**CITY OF PORTLAND, MAINE  
DEVELOPMENT REVIEW APPLICATION  
PLANNING DEPARTMENT PROCESSING FORM  
Planning Copy**

**2007-0088**  
Application I. D. Number

**Amendment to Plan - Mercy Hospital**  
Project Name/Description

**Subject:       Mercy Hospital  
                  Fore River Site Project Amendment**

EXCERPT OF  
 SITE LAYOUT PLAN - SOUTH (SHEET C-7)

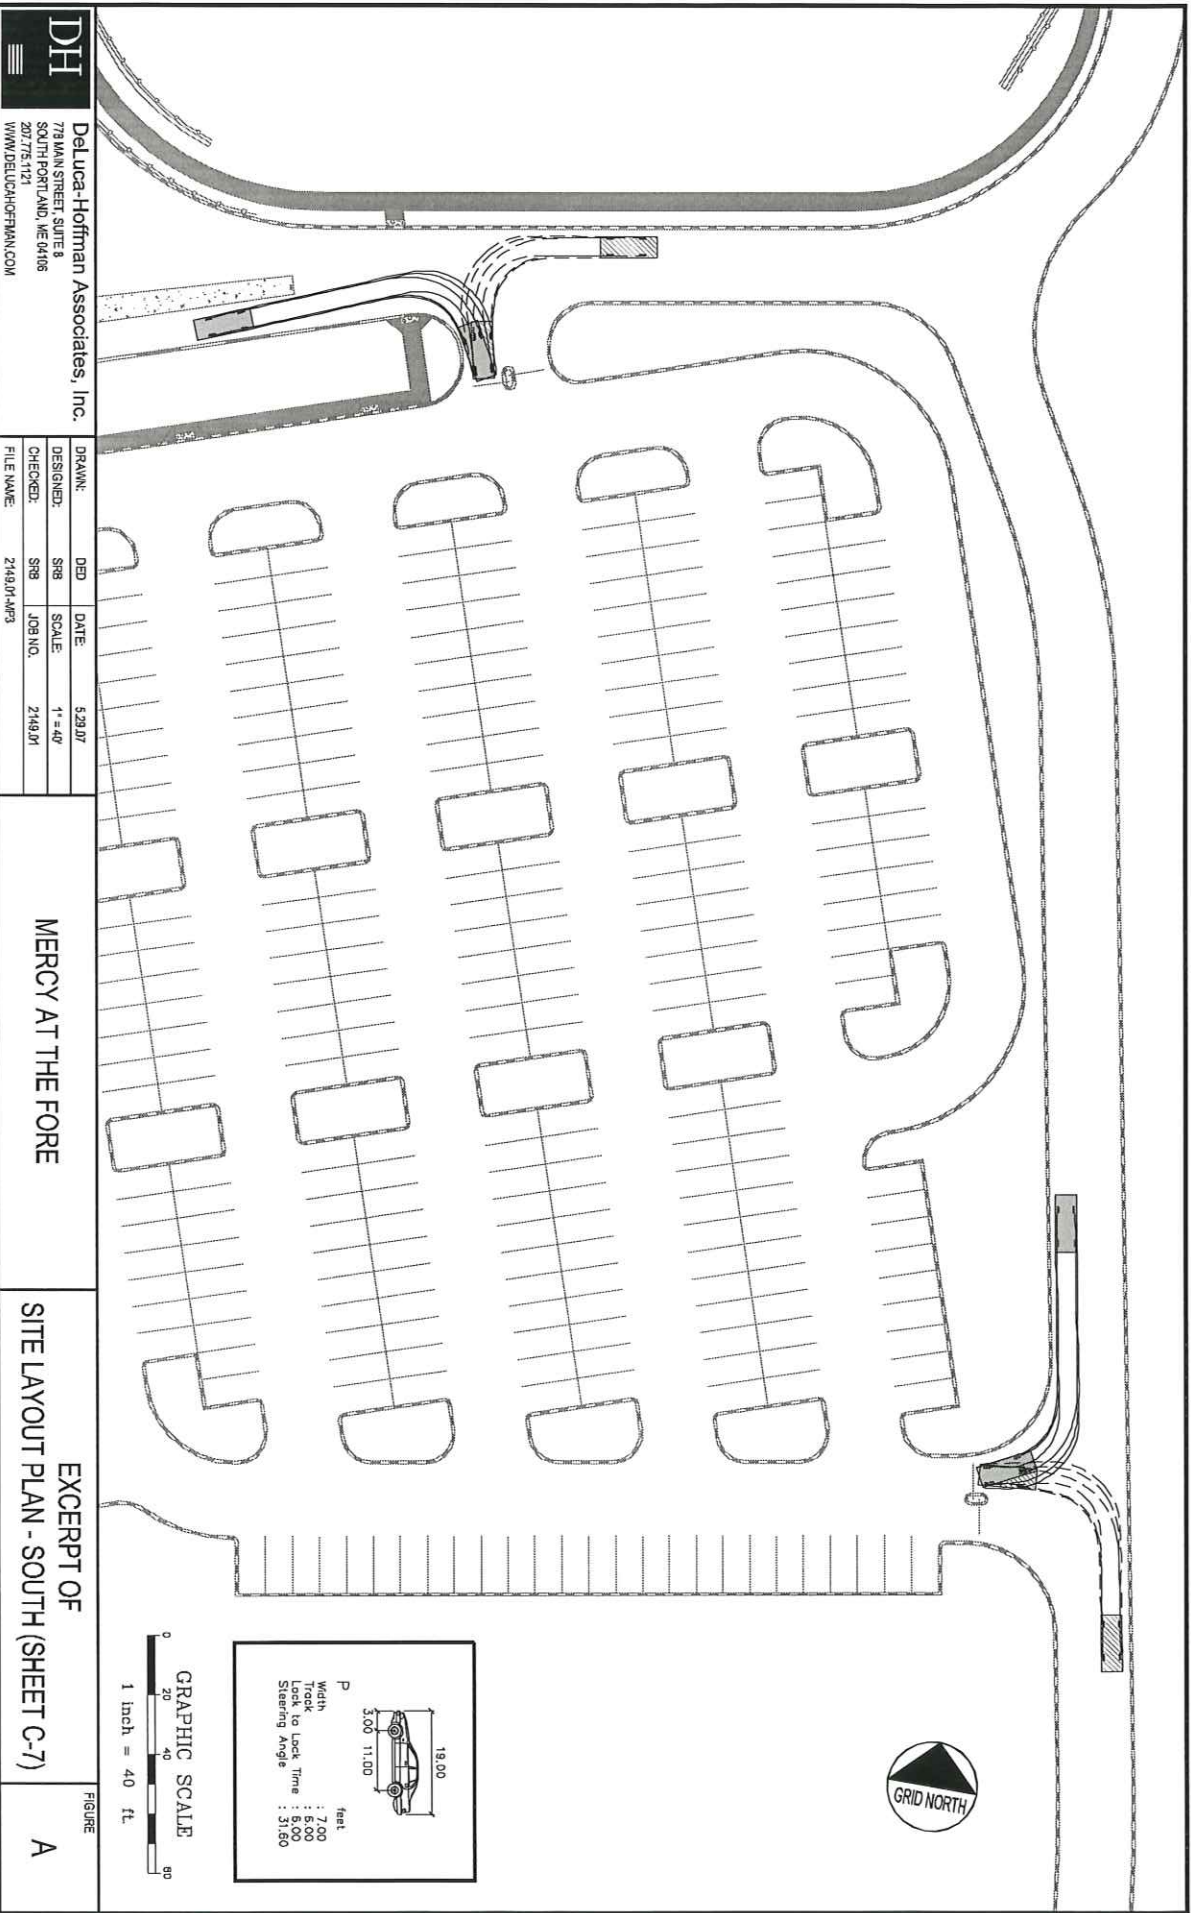
On behalf of Mercy Hospital we are submitting the accompanying materials in support of an amended site plan for the Fore River development site. The amended site plan specifically involves modifications to the parking lot layout at the southerly side of the site. Mercy's facilities managers have closely reviewed the parking lot configuration and wish to revise the layout to address the following issues:

1. Safety – The approved site plan includes multiple openings into the southerly parking lot off the easterly drive aisle that runs closest to the railroad tracks. This drive aisle is the designated delivery vehicle route and will also have a high percentage of traffic coming from the direction of I-295; thus the potential for conflicts may be greater with a higher number of parking lot entry points. Mercy is proposing to consolidate access off this drive aisle into one controlled access.

2. Security – The approved site plan also does not contemplate gate-controlled access into the parking area. In accordance with the Master Plan, the southerly lot will be a hospital employee designated parking lot. To better provide security and access control, Mercy is proposing to install gate control measures at two access points into the lot. The second access will be located per the approved design just off the southerly entrance drive. Each drive will have a narrow raised island on which typical parking lot gate controls can be placed and managed. Mercy also intends to install remote cameras for security coverage of the employee parking lot.

The proposed layout revisions result in a modest improvement to the overall landscaping coverage for the area to be revised. The revised layout results in a larger island that will separate the easterly drive aisle from the parking area. We have also eliminated the short length of sidewalk across the smaller intermediate islands as they no longer seem as functional or warranted. The following table summarizes the changes to the impervious and landscape areas within the southerly parking lot for the approved and proposed revised plans.

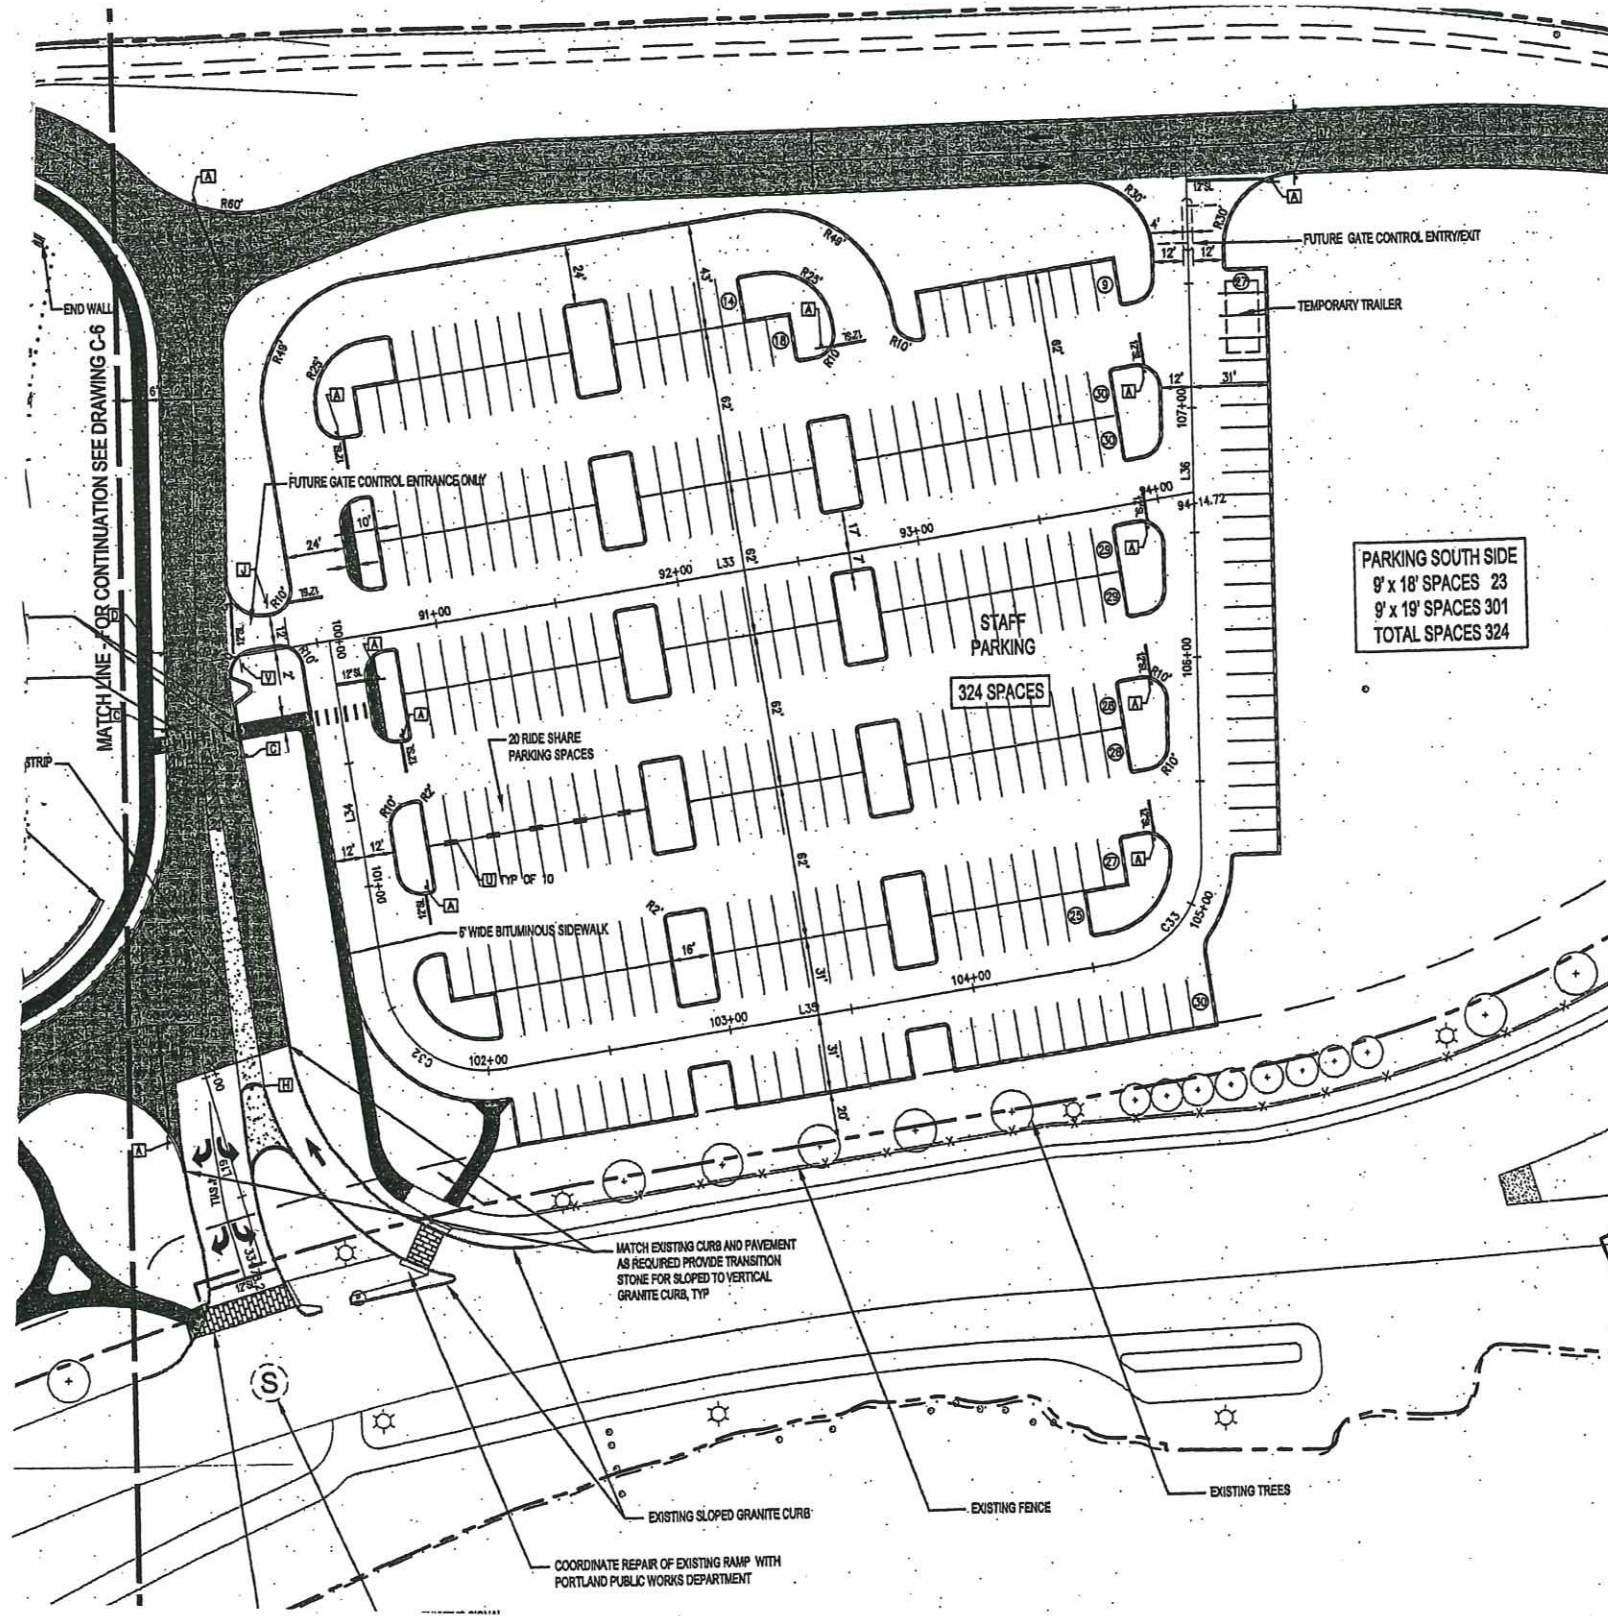
Jim Carmody and Tom Errico had some concerns and asked for more time to look at it closely and consult with each other- I think they will need more info as to how the entry system will work as the proposal does not show where queueing will take place and as it stand the peds will cross the queue waiting to get in.

- ① ck integration with sidewalks/trails
- ② ck landscape area/impact

SHEET TITLE  
SITE LAYOUT PLAN - SOUTH

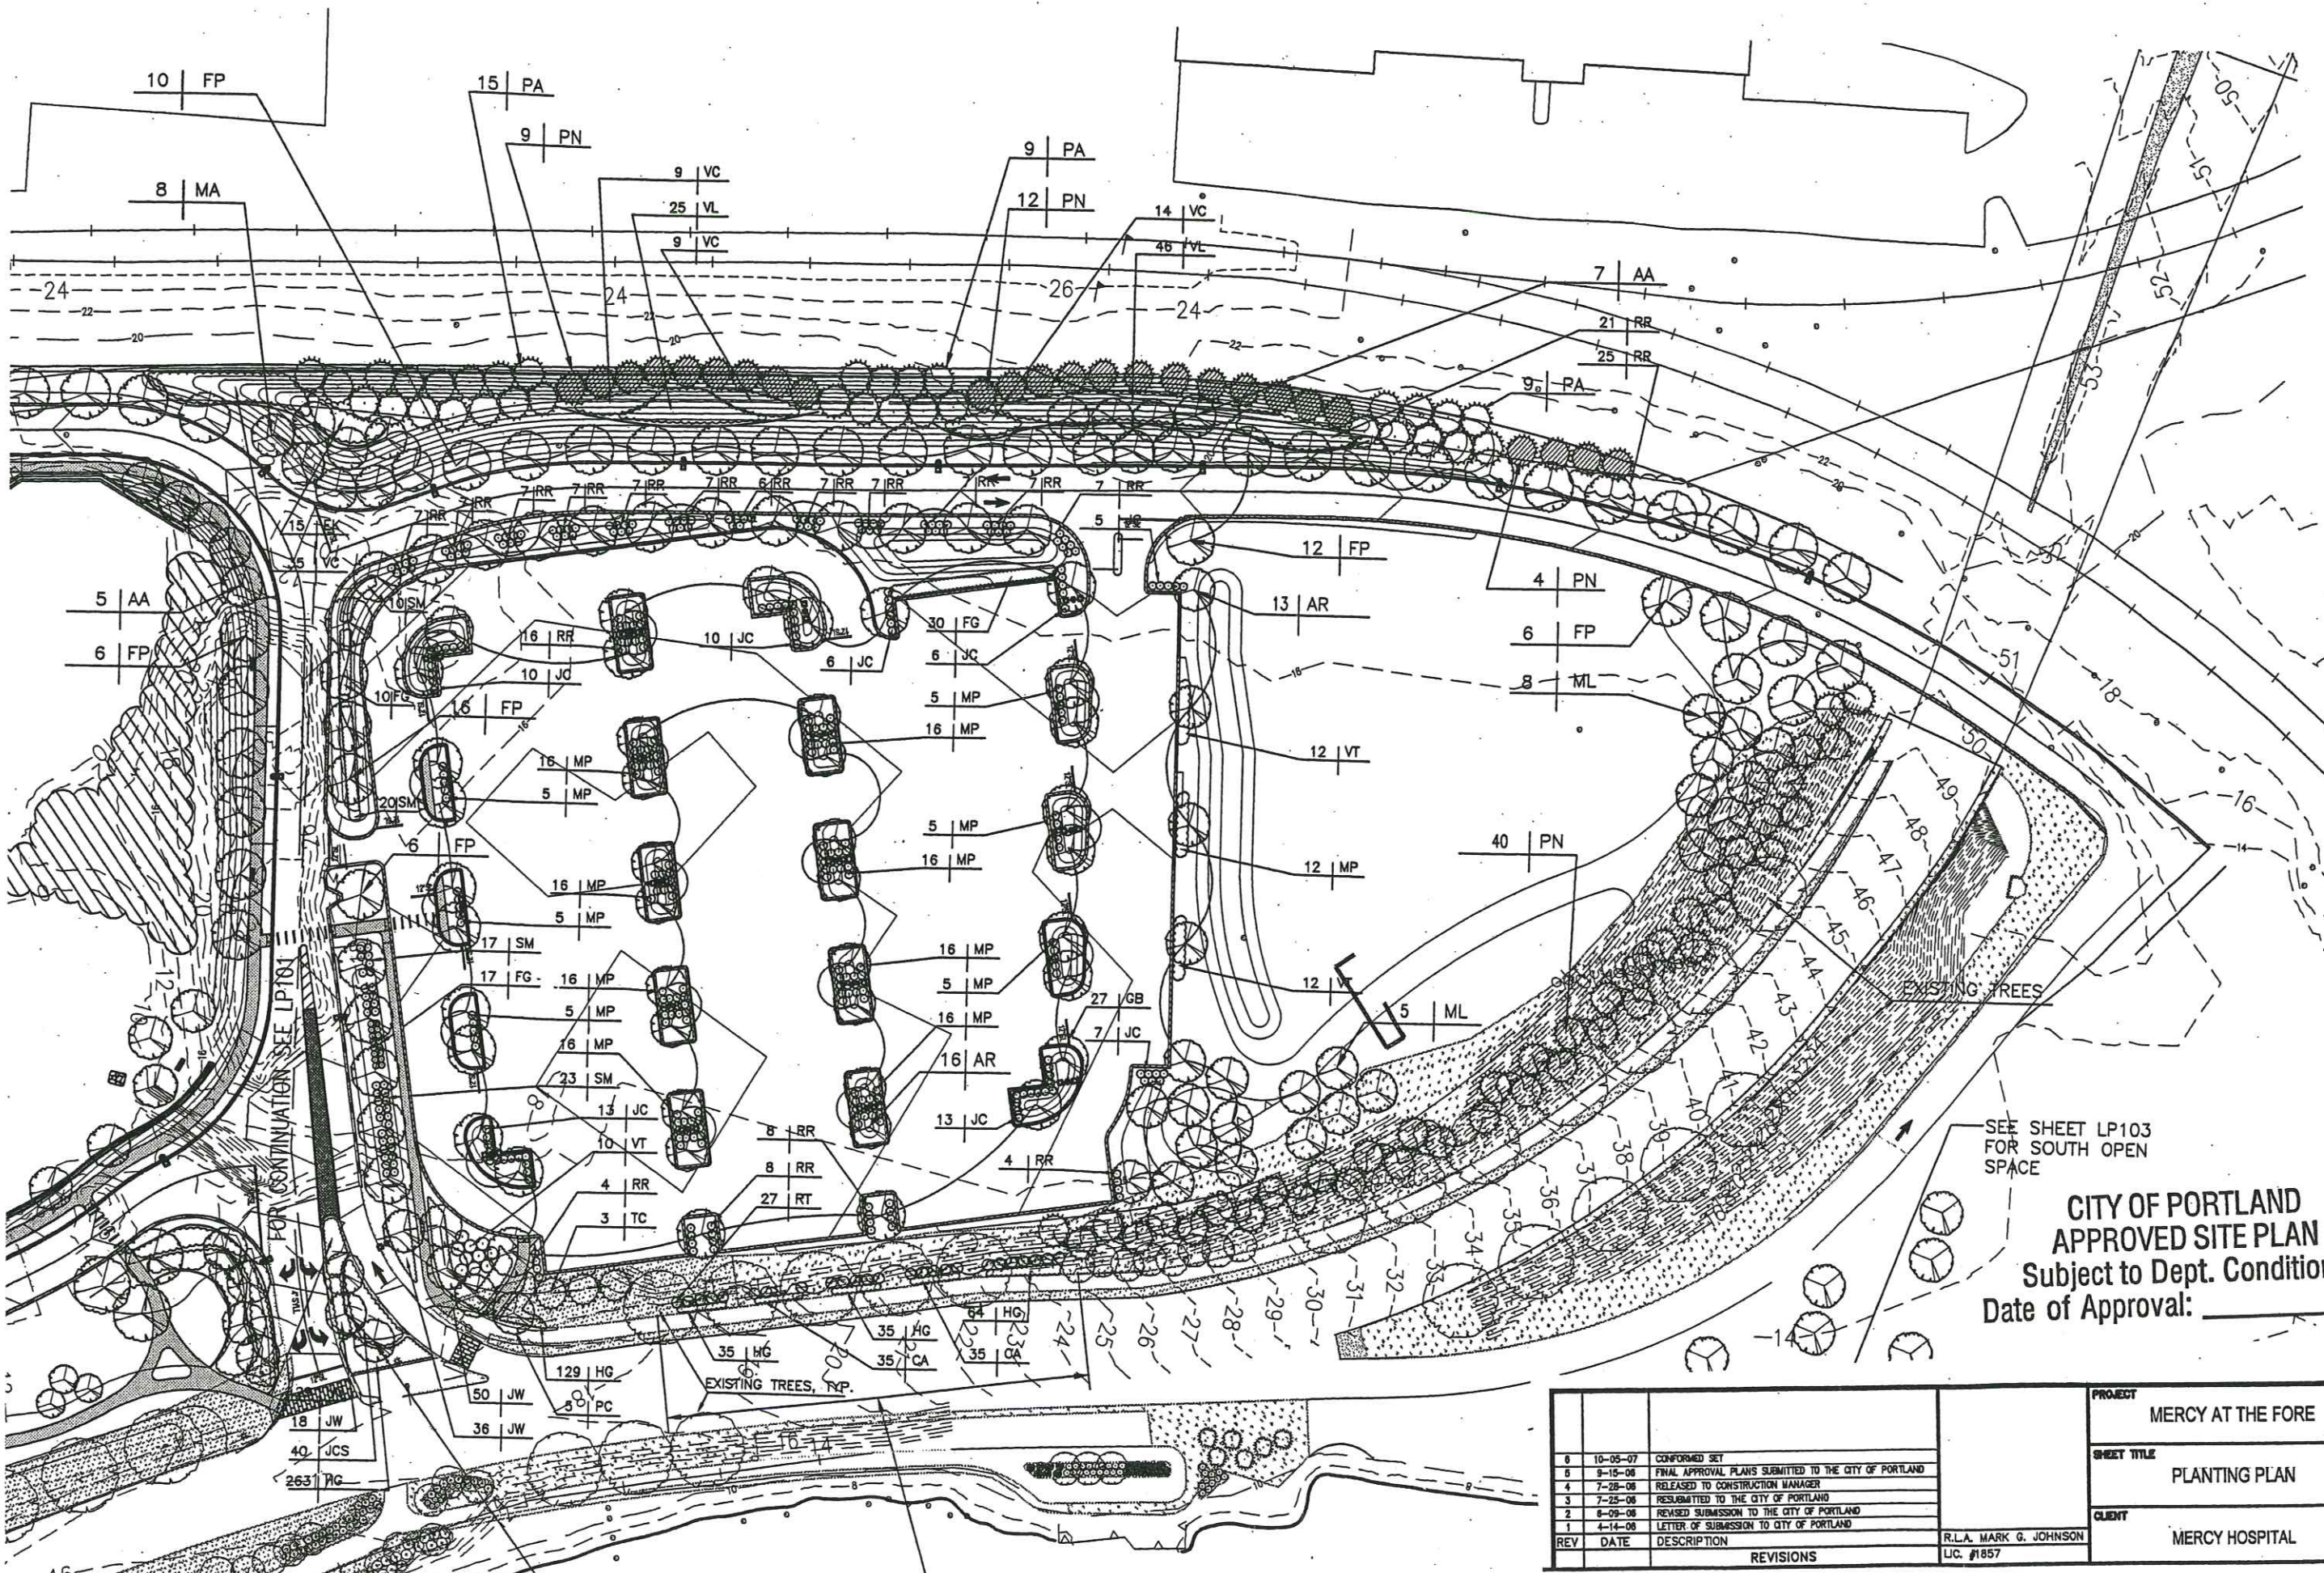
1. The location of the vehicle access points, gates, islands, aisles, striping etc are all acceptable as we had previously advised.
2. **Lighting:** The original proposal for 250 watt lamps is OK; the proposal for 400 watt lamps is not acceptable. While not a site plan requirement, I suggest the installation of additional low level "cut off" type perimeter lighting may be needed in several of the edge areas for personal safety reasons, with locations depending on the lighting levels generated by nearby streetlighting and the provision of lighting in relation to the proposed maintenance building and its access)

3. **Sidewalks:** the original parking lot proposal included a long length of central sidewalk leading to the crossing of the south access road near the pond. The modified parking lot layout resulted in the loss of this pedestrian route and there has been considerable discussion over what combination of relocated/new sidewalks, striping and related ramps should be introduced to ensure that safe and convenient pedestrian facilities are included in the modified layout. The anticipated desire lines within the parking lot as well as the need for links between the Connector sidewalk and the the parking lot and pond trail were taken into account.

- a. Retain all of the pedestrian proposals shown on the revised parking layout dated 6.11.07 but omitting the short segment of sidewalk on the one parking lot island nearest the Connector;
- b. Retain the sidewalk shown on the originally approved layout which skirted the NW corner but modifying the route of the sidewalk nearest the Connector so it would link directly into the stub of the Connector sidewalk, and also so that where it joins the eastern-most crossing of the South Access road (at right angles) there is sensible transition so that users do not need to go down an angled tipdown and then up again to reach the crossing (one suggestion was to provide an at grade level wedge around the back of the tipdown but there may be a better solution as we discussed).

The objective is to create a level and direct link between the Connector sidewalk and the crossing which goes over to the pond trail; I understand you will send a revised PDF showing how these two issues can be resolved.
